HISTORIC AND DESIGN REVIEW COMMISSION

HDRC CASE NO: 2021-501
ADDRESS: 209 ALAMO PLAZA
LEGAL DESCRIPTION: NCB 145 BLK LOT 5
ZONING: D, H, RIO-3
CITY COUNCIL DIST.: 1
DISTRICT: Alamo Plaza Historic District
APPLICANT: David Hannan/Fisher Heck Architects
OWNER: Suzy Pack
TYPE OF WORK: Installation of a storefront system, exterior modifications, repair and maintenance, canopy installation
APPLICATION RECEIVED: September 28, 2021
60-DAY REVIEW: Not applicable due to City Council Emergency Orders
CASE MANAGER: Edward Hall
REQUEST:

The applicant is requesting a Certificate of Appropriateness for approval to:

1 WEST EXTERIOR ELEVATION
1/4" = 1'-0"

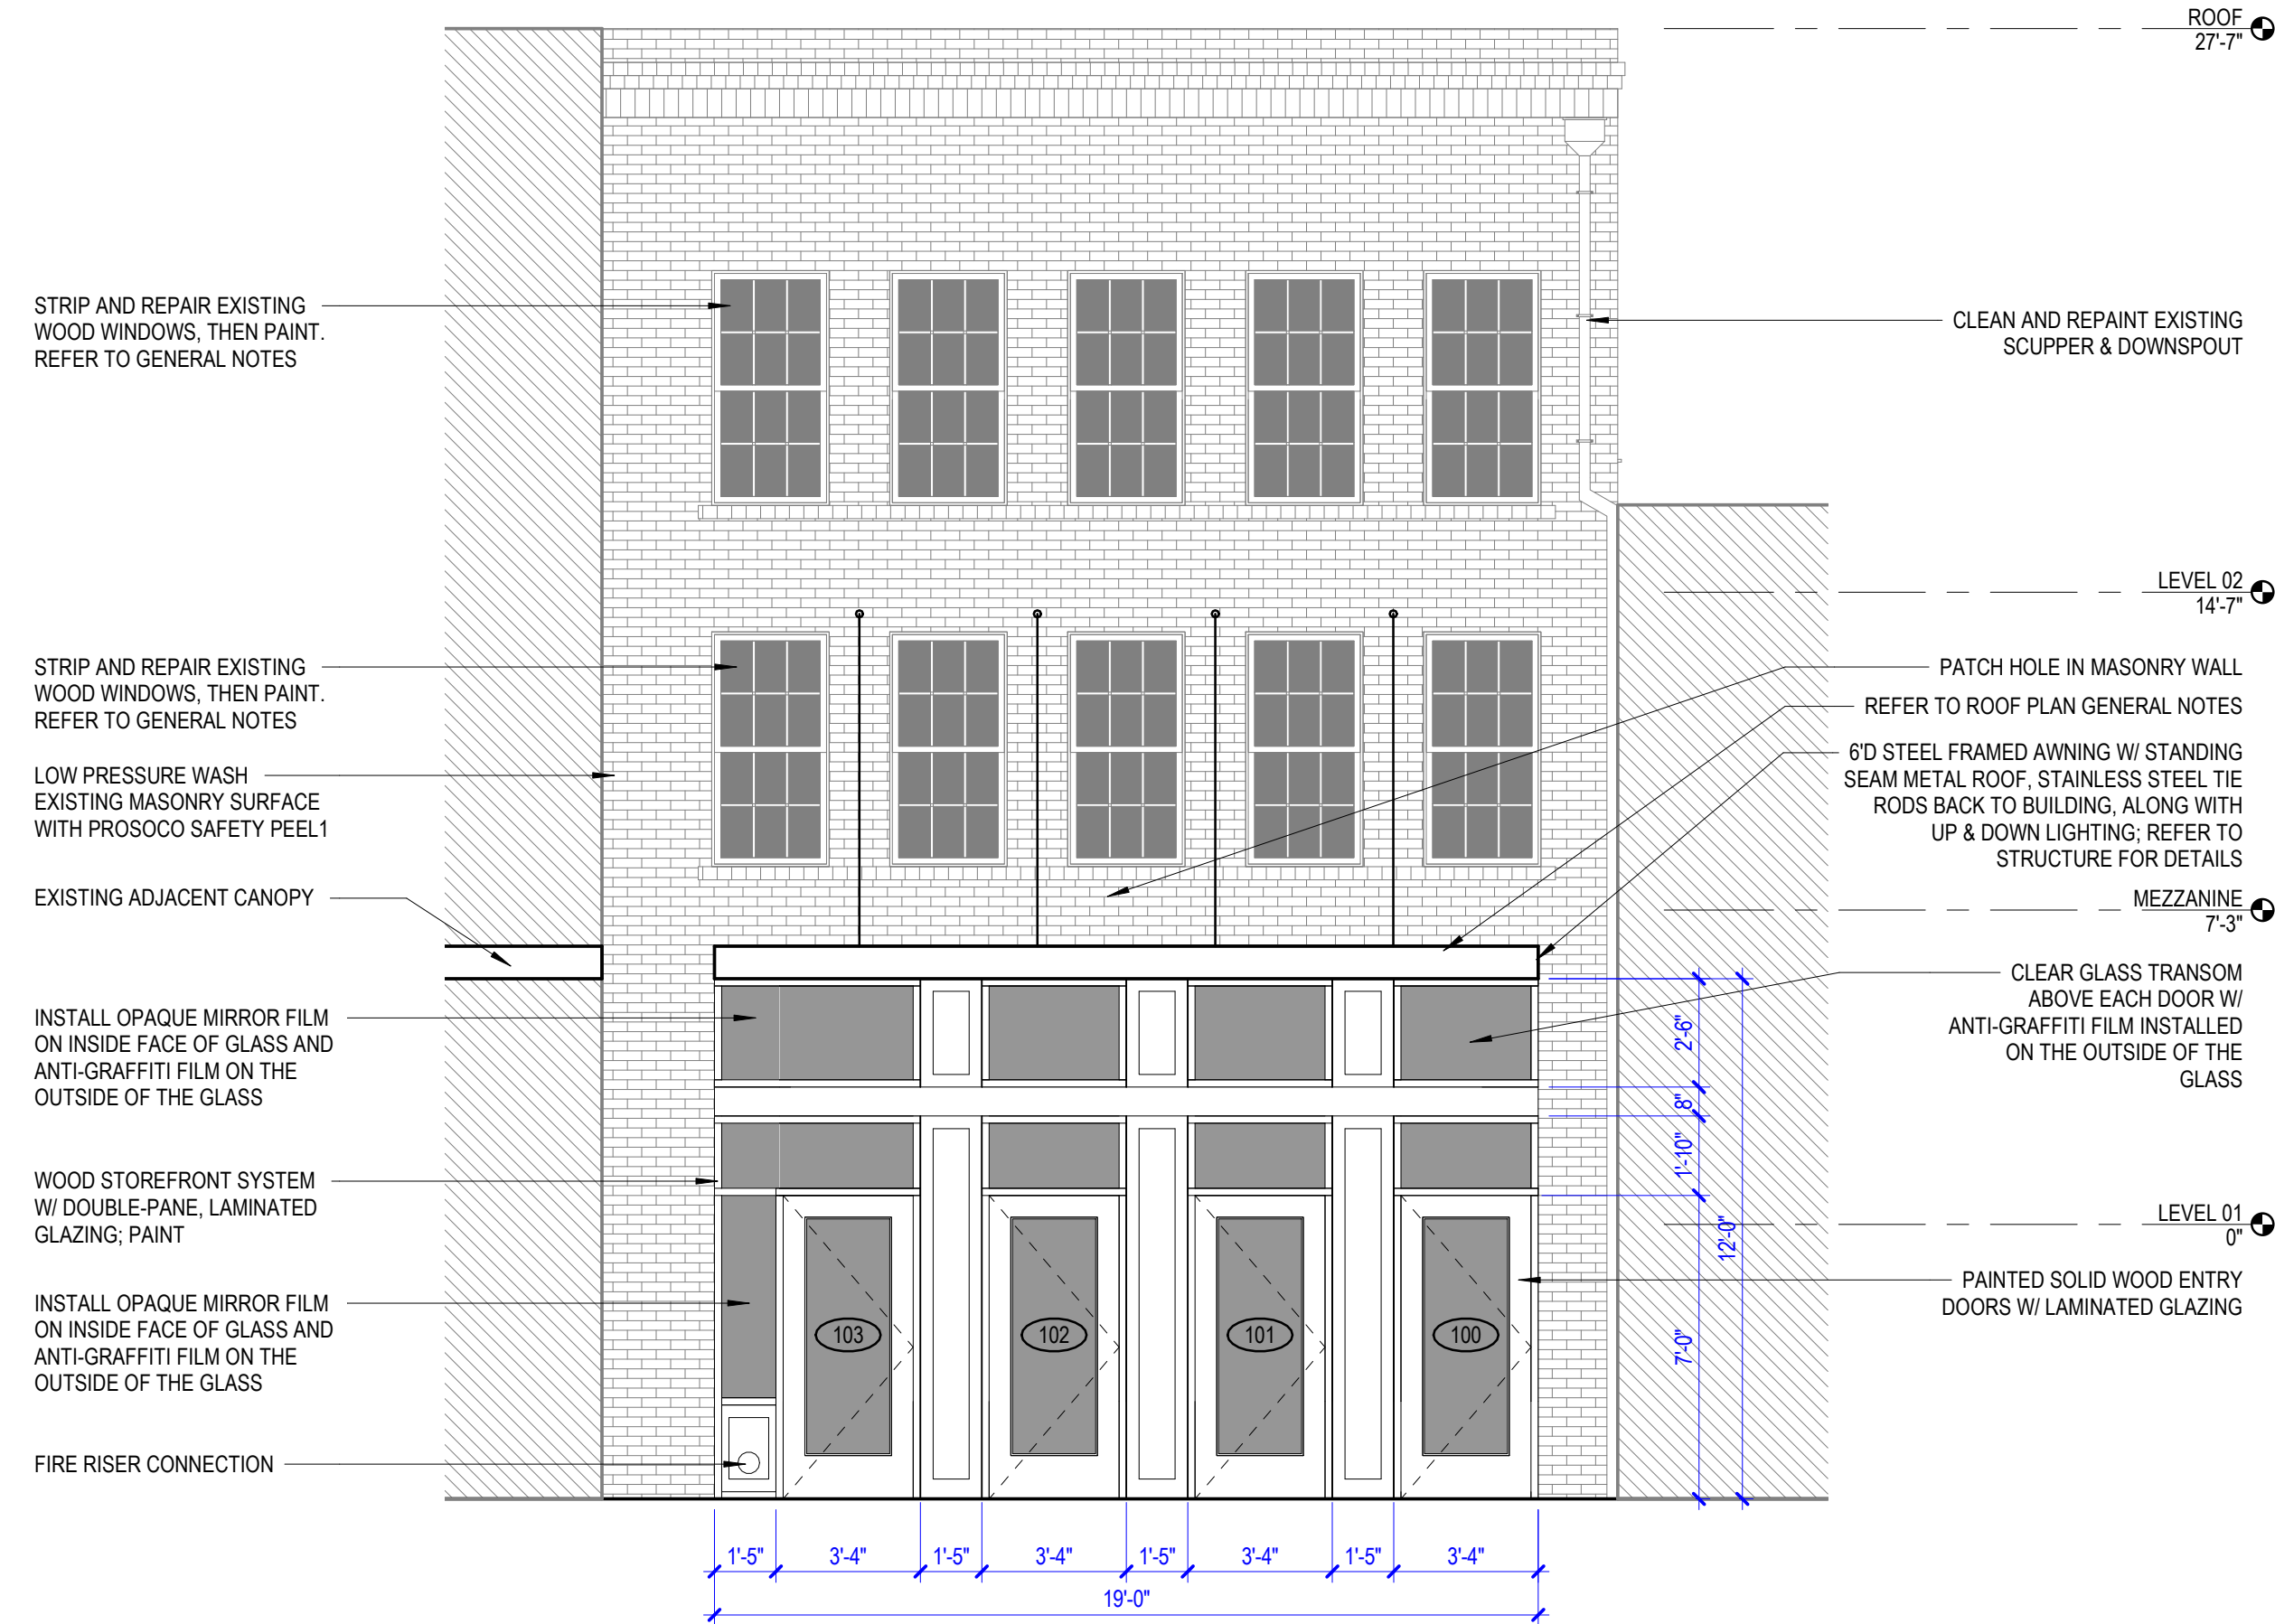
- d. STOREFRONT SYSTEM – The applicant has proposed to install a new, wood storefront system on the west façade to feature wood doors and a key box. The existing storefront system has been obscured by non-original building materials. The Guidelines for Exterior Maintenance and Alterations 10.B.ii. note that non-historic facades should be returned to their original design based on photographic evidence. When evidence is not available, the scale, design, materials, color and texture of new materials should be compatible with those of the historic façade. Generally, staff finds the profile of the storefront to be appropriate.

- e. CANOPY – The applicant has proposed to install a new steel framed canopy on the west façade. The Guidelines for Exterior Maintenance and Alterations 11.B.ii. notes that canopies should be added based on accurate evidence of the original, such as photographs. If no such evidence exists, the design of new canopies and awnings should be based on the architectural style of the building and be proportionate in shape and size to the scale of the building façade to which they will be attached. Generally, staff finds the installation of a canopy on the west façade to be appropriate; however, staff finds that the proposed height of the canopy is atypical with the historic placement of canopies, which are typically located above the storefront system and beneath transom windows. Additionally, staff finds that the proposed standing seam metal roof that is proposed for the canopy should feature smooth panels that are 18 to 21 inches in width, seams that are 1 to 2 inches in height, crimped ridges and a standard galvalume finish. Panels should not feature striations or corrugation. Lastly, staff finds the profile of the canopy, with an exposed steel beam to be atypical with historic canopy design. Staff finds that the proposed canopy should feature a profile that is consistent with historic canopy details. Canopy rod anchors should not be installed through the face of historic masonry.

- 2. Staff recommends approval of item #2, the installation of a new storefront system on the rear (west) façade, with the following stipulations:
 - i. That the applicant submits a detailed section of the new storefront system to staff for review and approval.

- ii. That the applicant submits the proposed wood doors to staff for review and approval.
- 3. Staff recommends approval of item #4, the installation of a new canopy with the following stipulations:

- i. That the canopy's height be reduced to be placed consistently with historic examples; commonly immediately between the storefront system and transom windows.

- ii. That the proposed standing seam metal roof that is proposed for the canopy should feature smooth panels that are 18 to 21 inches in width, seams that are 1 to 2 inches in height, crimped ridges and a standard galvalume finish. Panels should not feature striations or corrugation.

- iii. That the proposed canopy should feature a profile that is consistent with historic canopy details, The exposed steel beam should be modified or covered.
